Memorandum of Addendum #3

January 20, 2021

Re: **Addendum No. 3**
Sampson County 911 & ES Facilities
Clinton, NC
ADW Job No. 20003

BOLLARD DETAIL | SCALE: 3/4"=1'-0" | 4

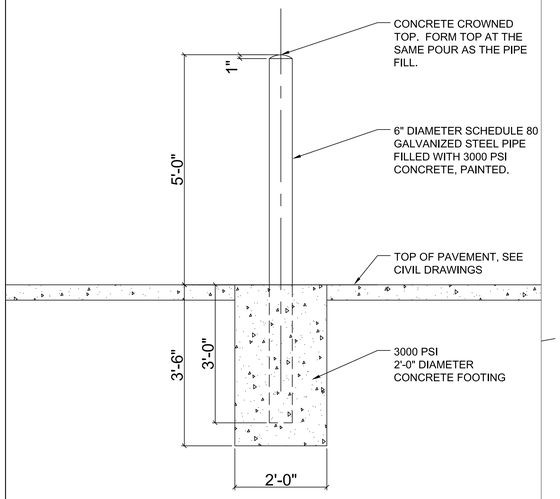
Section 05 50 00 – Metal Fabrications: **Replace** paragraph 2.11 METAL BOLLARDS with the following:

48. The drawings show about 70 pipe bollards around the vehicle bays. In the specifications it lists surface-mounted and removable bollards. Can you provide clarification on the size and type of bollards to be used along with details on the installation methods? **No pipe bollards are to be surface mounted or removable. <u>Section 05 50 00 – Miscellaneous Metals</u> will be revised in this addendum.**

2.11 METAL BOLLARDS

A. Fabricate metal bollards of 6" diameter hot-dipped galvanized Schedule 80 steel pipe.
B. Construct bollards with concrete footings as indicated in the drawings
C. Fill bollards with 3000 psi concrete and form a dome from the same concrete pour at the top of the bollard.
D. Paint the bollards as specified in Section 09 91 00 – Painting.

CASEWORK ELEVATION | SCALE: 1/2" = 1'-0" | 13

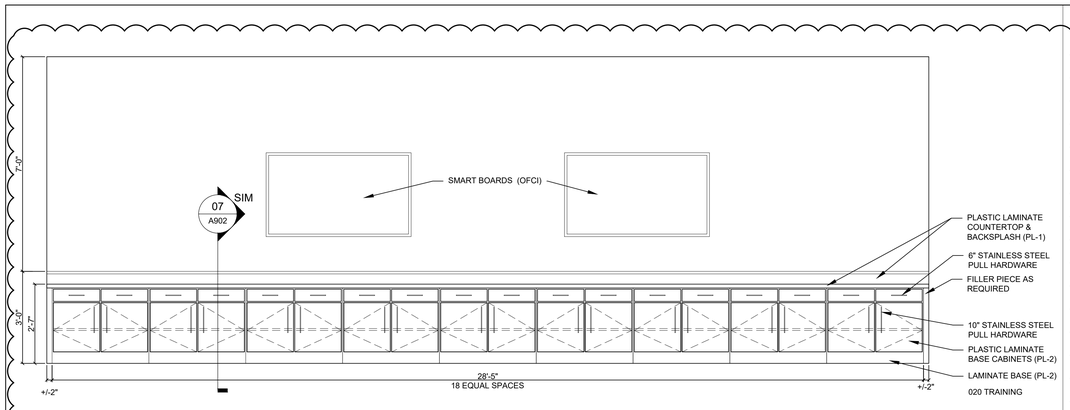
40. Room 020 Training appears to have casework on the north wall, where is this detailed? **Elevations and a casework section cut will be added in an upcoming addendum.**

1 SITE PLAN - ELECTRICAL

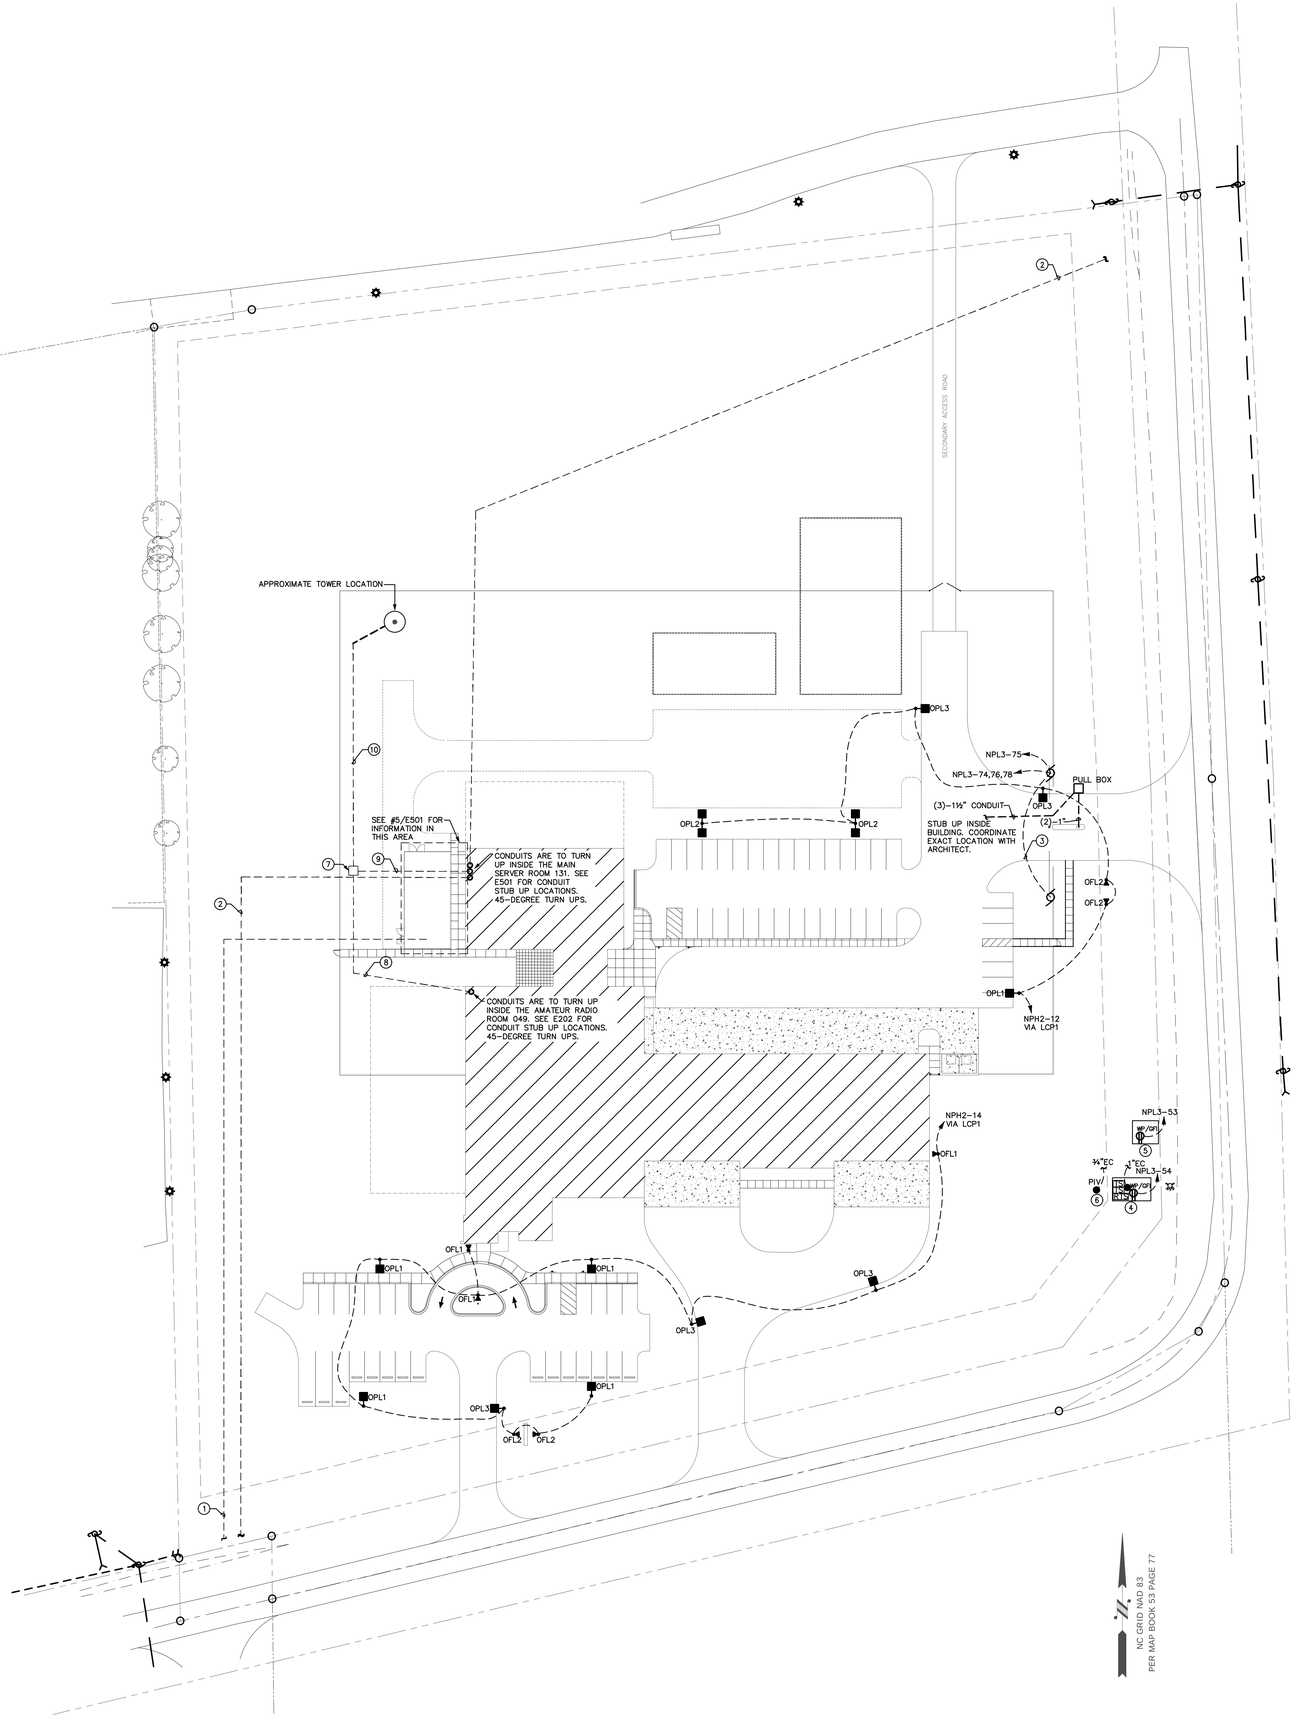
18. The General Note on drawing E010 calls for 36" x 36" hand holes for all low voltage cable unless otherwise indicated by the local utility. Low voltage according to the specification is anything 600V or less, meaning everything applies. Please advise as to the quantities actually needed. Attempts to get reliable information from Duke Energy/Progress have been unsuccessful. **This note applies to site Tele/Comm conduits to the property line, conduits to the antenna, etc. This does note does not apply to the power utility incoming conduits.**
